**Sent:** 10/02/2021 4:39:31 PM  
**Subject:** DA 2021/0006  
**Attachments:** Submission - Spitzer - 8 Jamieson Parade, Collaroy.pdf;

## **SUBMISSION TO DA 2021/0006**

### **Impacts at 8 Jamieson Parade, Collaroy from the proposed redevelopment of 10 Jamieson Parade, Collaroy.**

**Figure 1 - The southern elevation of the proposal and the location and extent of planning control exceedances (source: excerpt architectural plans)**

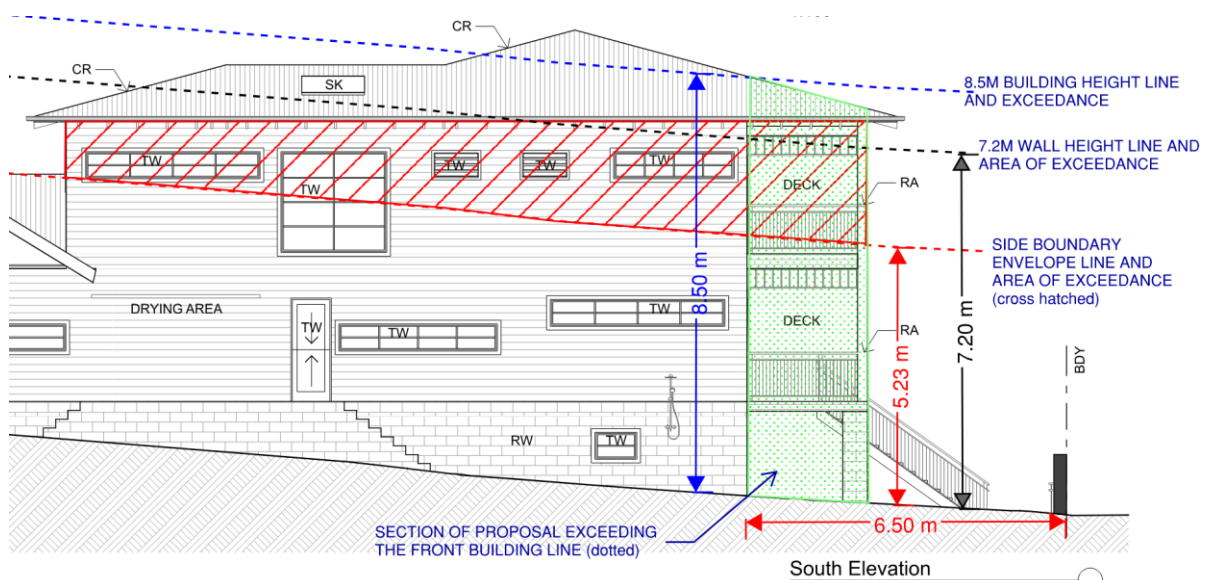
The proposal involves a significantly non-compliant upper level (as illustrated within Figure 1 below) that would be adjacent to several valued north facing rooms and spaces, including the parents retreat/main bedroom, living room, and front balconies within my client's property.

Furthermore, solar panels are installed along the north facing section of roof of my client's property. The side boundary envelope and wall height exceedances are adjacent to this area. Due to their non-compliance, additional shadow will be cast which will negatively impact upon the solar panels function during the midwinter period. A compliant design would have a reduced impact.

The proposal also exceeds the height of buildings development standard which contributes to the proposed height of the southern façade. In this regard objective 4.3(b) of the LEP states:

A design that was compliant with the above referenced controls would have a reduced solar impact, therefore, in my opinion this exceedance is insufficiently justified by the proposal and forms a reason why the DA is unacceptable in its current form.
